ERIE CANAL HARBOR DEVELOPMENT CORPORATION

SUBJECT: Children's Museum - South Aud Block Redevelopment (130 Main Street)

Design Review Committee (DRC)
South Aud Block Redevelopment • Design Review Recommendations

**Re: Echdc's Drc Review Recommendation Response Letter:
South Aud Block Redevelopment
Canal Side Project, Buffalo NY**

East Exterior Elevation

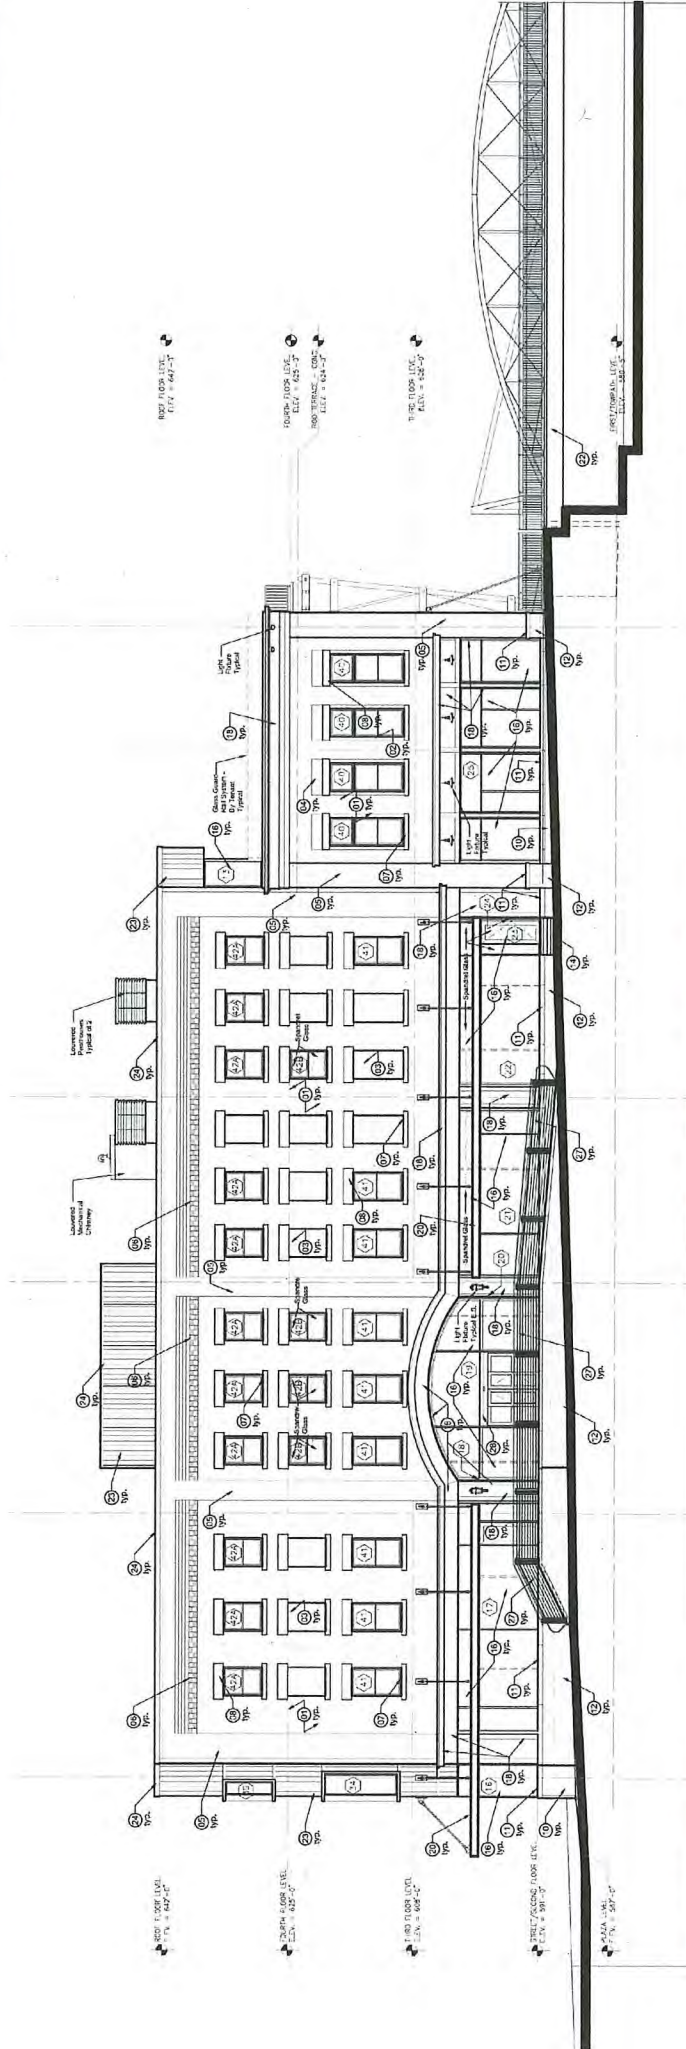
- The DRC needs to see a sample of the spandrels glass that is proposed on the east elevation.
- The design guidelines require the building glass be clear. The glass is clear, but is then treated with a metallic low-e coating, which helps energy performance, but in my opinion reduces the light transmittance value, but more importantly adds to the reflectivity of the glass from the outside during the day, and adds to the reflectivity at night from the inside. The intent of the guidelines is to promote TRANSPARENCY. A good mock up might prove otherwise to the DRC.
- Note that the colored rendered elevations do not match the technical elevations.

West & South (Splayed) - Exterior Elevation(s)

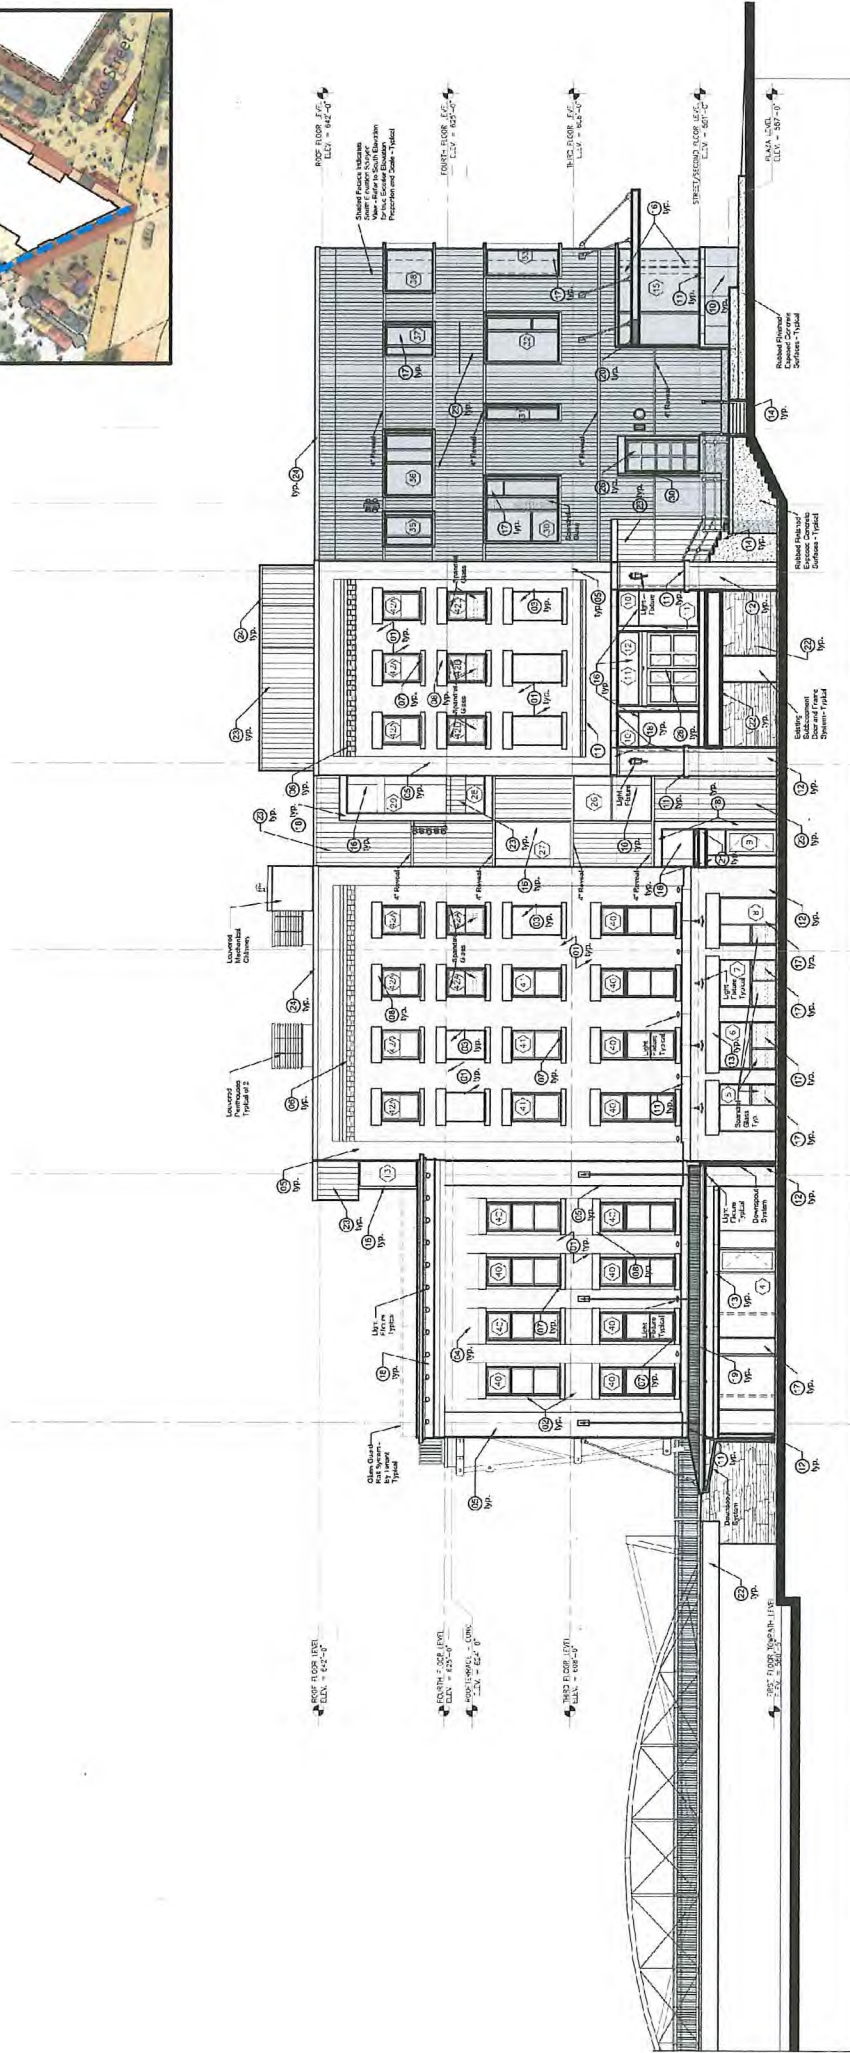
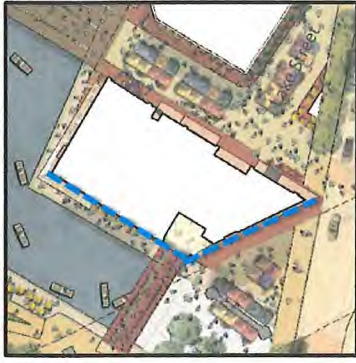
- This approval would be contingent of a future review of proposed signage. The west and south elevations lacked the visual delight and invention mentioned in the design guidelines. The entrance at door 01 also lacked the visual delight. As mentioned above: the corner on Marine Drive might be a place for for a large vertical sign the height of the building elevation.

South Exterior Elevation

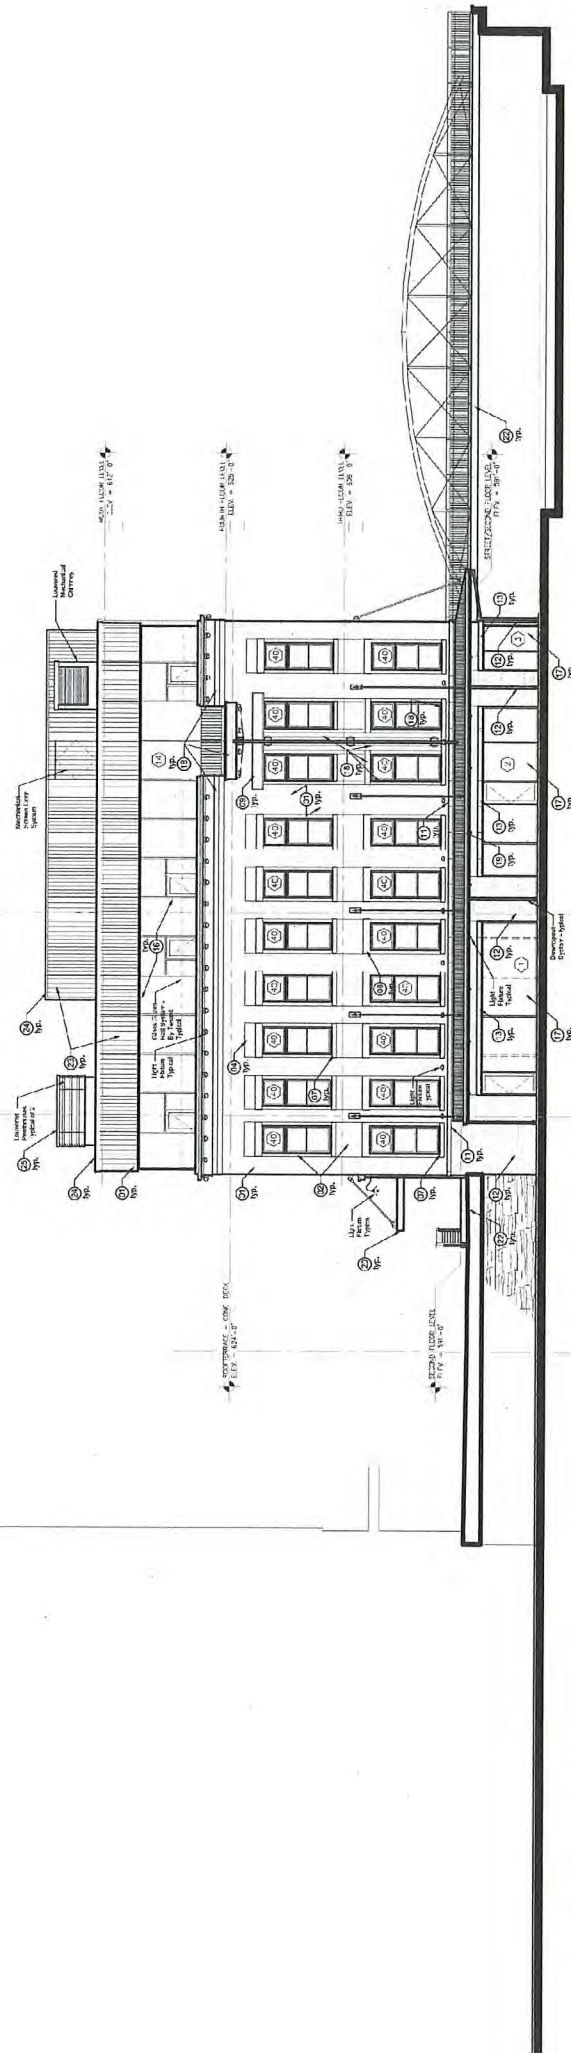
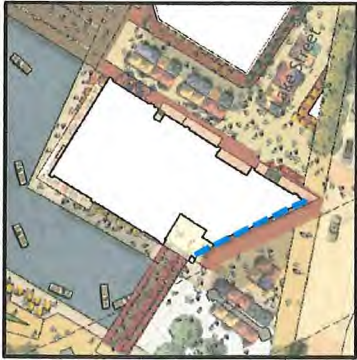
- Light fixtures at both entrances should be bold & very special, and much larger.
 - THIS WILL BE REVIEWED FURTHER BY ECHDC AND THE MUSEUM.
- The south elevation with the ribbed metal is weak. The window pattern doesn't contribute to Canalside. This would have been a perfect opportunity for a very glassy elevation showing off the guts of the building.

- THE SOUTH FACE IS NOT AN HISTORIC FAÇADE BUT IS A "SECTIONAL CUT" THROUGH THE LOCATION OF A FORMER BUILDING. INTERPETING THIS "CUT" WITH A METAL FINISH AND CONTEMPORARY WINDOWS MAKES THIS CLEAR. THE SIMPLE TREATMENT ALSO IS CONSCIOUS OF THE FACADES LOCATION UNDER THE SKYWAY AND ITS USE AS AN AREA OF REFUSE.
